Planning Sub Committee – 10 January 2022

ADDENDUM REPORT FOR ITEMS

UPDATE FOR CONSIDERATION AT PLANNING SUB-COMMITTEE Item No. 3

Reference No: HGY/2021/2882	Ward: Seven Sisters
Address: Land adjoining Remington Road and Pulford Road London N15	
Proposal: Redevelopment of site including demolition of garages to provide 46 new homes for Council rent (Use Class C3) comprising part 3, 5 and 6 storey apartment buildings (31 homes) and 1, 2 and 3 storey houses and maisonettes (15 homes) with associated amenity space, landscaping, refuse/ recycling and cycle storage facilities. Reconfiguration of Remington Road as one-way street, 7 on-street parking spaces, children's play space, public realm improvements and relocation of existing refuse/recycling facilities.	
Applicant: LBH Haringey	
Ownership: Council

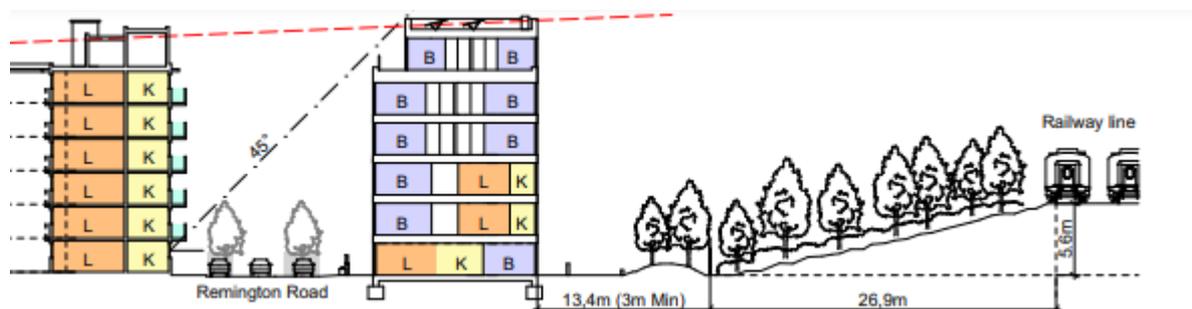
Representation	Applicant response
<p>If you are talking about the land by the bridge. In the fifties a train came off the tracks and rolled down the bank into the street. The Council gave the families assurance that the ground would not be built on. So many people lost loved ones and it was the people in the street houses that spent five days to dig them out. So are you saying the Council are going back on their word.</p> <p>Don't let the promise the Council made to the dead be broken.</p>	<p>The proposed development has been designed having regard to the constraints and opportunities presented by the site and local housing need.</p> <p>It is not uncommon for new residential development to be located close to railway lines; however, the proximity of the railway in this instance has been considered in consultation with the rail operators and the site is not considered inappropriate for residential purposes. Should the planning application be approved, further engagement with the rail operators will take place to ensure the development is compliant with the appropriate regulations.</p>

Through the S105 consultation process, 671 households were consulted who live close to the proposed site to inquire if they use the open space.
In summary:

- Only 17 use the open space.
- Only four use the open space on a daily basis.

At the statutory consultation, there were no objections from households who live in the immediate area.

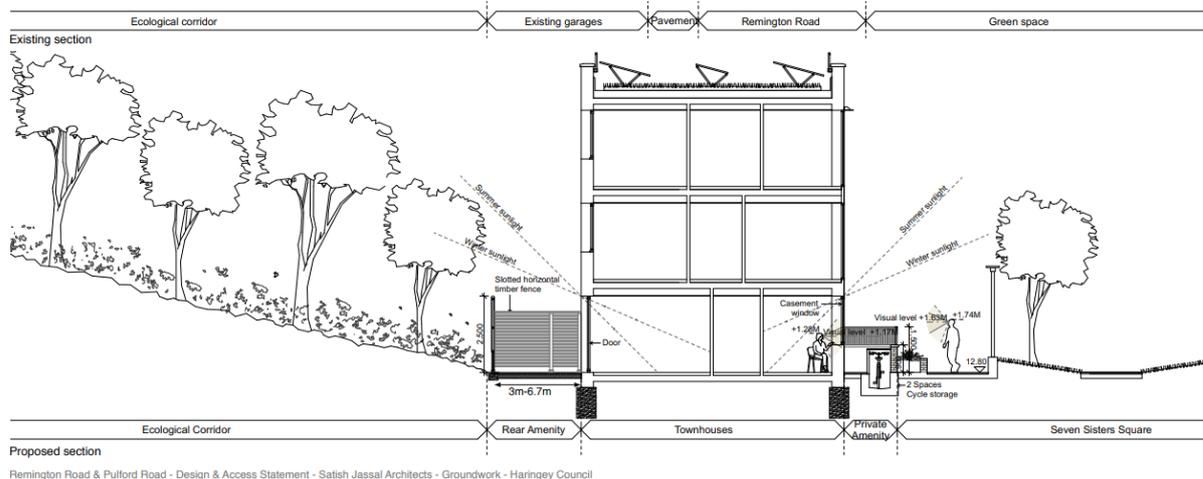
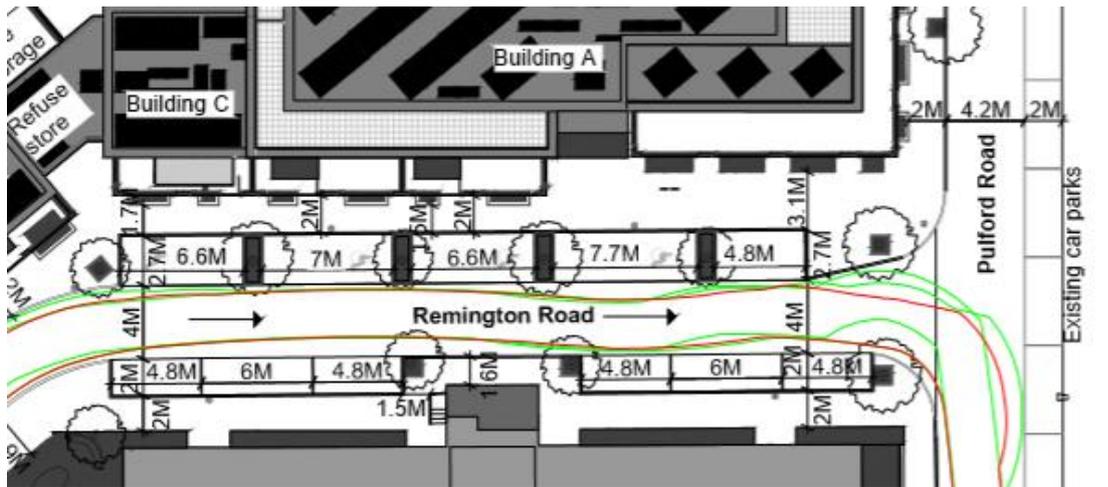
One concern with the daylight and sunlight report produced is that as standard they don't include trees in its analysis of light levels, while this raises concerns for the disabled residents who will already face low or no level of sunlight outlines above as there will be trees introduced outside of their home at the front and rear (x amount of trees added to rear communal garden) and this dense tree growth should have been analysed in the daylight and sunlight report)

However this decision was particularly inappropriate at the rear of the townhouses

These face out towards the slope of the railway line and face a thick forest of trees which rises to 3 stories above them. As show on the diagram above, only during the height of summer would light reach the ground floor windows of the homes, and the gardens would never receive direct sunlight. In the Townhouse type TH.C this ground floor room would be the dining/living room and would receive no through light from the front of the house due to internal walls, leaving the main living space of the homes receiving sunlight only on rare occasions in summer.

Even with the current report Of the 18 private gardens, 14 receive less than 2 hours of sunlight on March 21st in all of the garden and only two actually meet the requirement of half of the garden receiving 2 hours of sunlight on March 21st. The communal garden isn't analysed but as the gardens that surround it don't meet the requirement it's safe to assume it doesn't either. It is hard to give much credence to the claim that this green space is improved then, as a North facing communal amenity space is a negative in their own analysis and this one in particular is likely to not reach the BRE standards for light, which the current layout does achieve.

The daylight and sunlight for internal rooms assessment has been carried out based on the established BRE criteria.

BRE guide for external spaces is intended to be used flexibly, particularly in urban locations, and the assessors are of the opinion that the proposal still provides a good level of external amenity for its future occupants, especially when taking into account the site constraints.

All outdoor amenity spaces are usable and attractive. The northeast facing communal amenity space is supplemented with new south facing amenity spaces such as Seven Sisters Square. No home has a private amenity space that faces solely due north.
